PRIMARY DRIVE CHAIN CARE - ELECTRA-GLIDE**NEW DESIGN CHAIN FOR REPLACEMENT**

Starting on September 2, 1965 all Electra-Glide motorcycles shipped from the factory will have Duckworth primary drive (double width) chains with plates having straight sides.

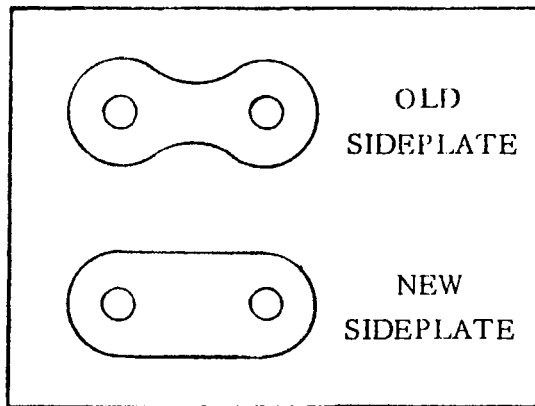
Premature chain wear can be caused by engine and clutch sprocket misalignment. Starting with 1966 season, changes to obtain better front sprocket adjustment were made in the Electra Glide model. These changes include new variable thickness sprocket spacers which can also be applied to 1965 Electra Glides. Whenever a new chain is installed on 1965 Electra Glides

be sure to get the correct front sprocket alignment using sprocket shaft spacers of correct width according to the following measurements.

With clutch disassembled from clutch hub and compensating sprocket disassembled from sprocket shaft as illustrated, determine spacer (6) thickness as follows:

In this case a .240 in. thick spacer would be added to existing .336 standard spacer to obtain chain alignment.
